ADDENDUM 4
Via E-Mail
DATE: May 7, 2024

Contract: 23-C-00013; Morris Bridge Filter Building Improvements ReBid

Item 1- RFI's and Responses follow:

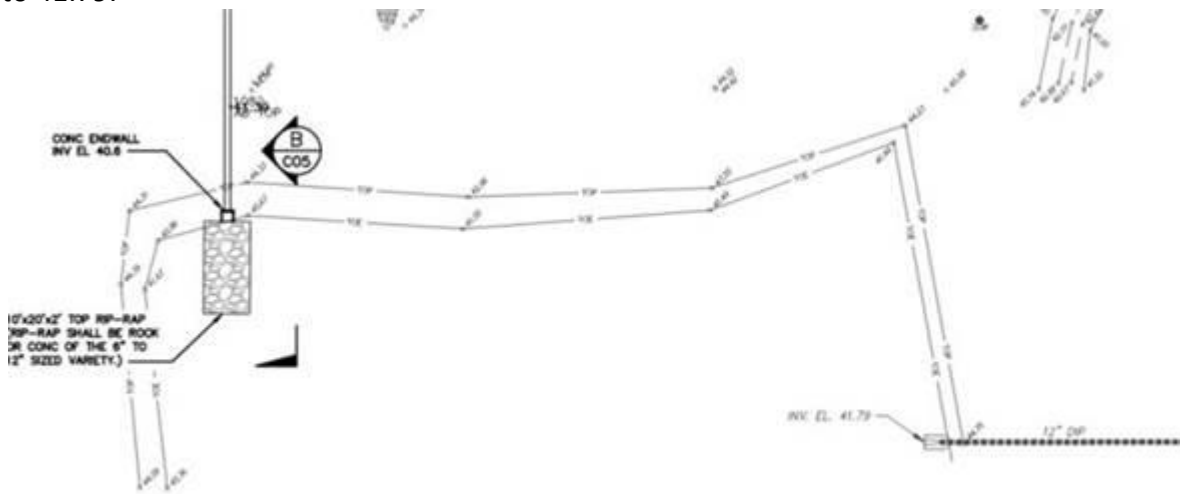
2. FL-A-302 note N06 state replacing wall panels above door. Picture taken at site visit does shown framing of existing condition (see attached).
 - a. Keynote N06 on sheets FL-A-301 and FL-A-302 states 'Replace missing panel over galvanized furring to match existing with matching trim'.
 - b. There is a missing panel like the adjacent panels shown in the image below.
